Rezoning Transportation Analysis

Petition Number: #2022-047

General Location Identifier: 09513114

Date	Description
08-22-2022	First Review (AO)
09-21-2022	Second Review (AO)

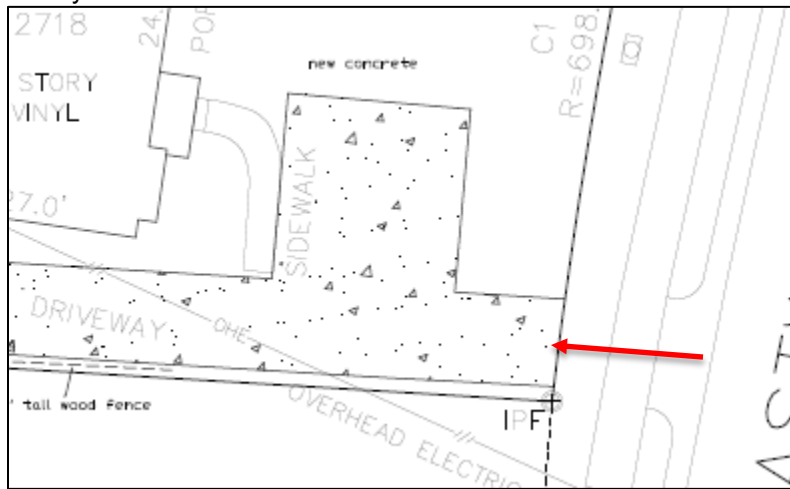
2. **Outstanding Comment from 8-22-22:** Revise site plan and conditional note(s) to commit to dedicate 40-feet of right-of-way from the road centerline of Eastway Dr. The site plan shall label and dimension the right-of-way from the road centerline.
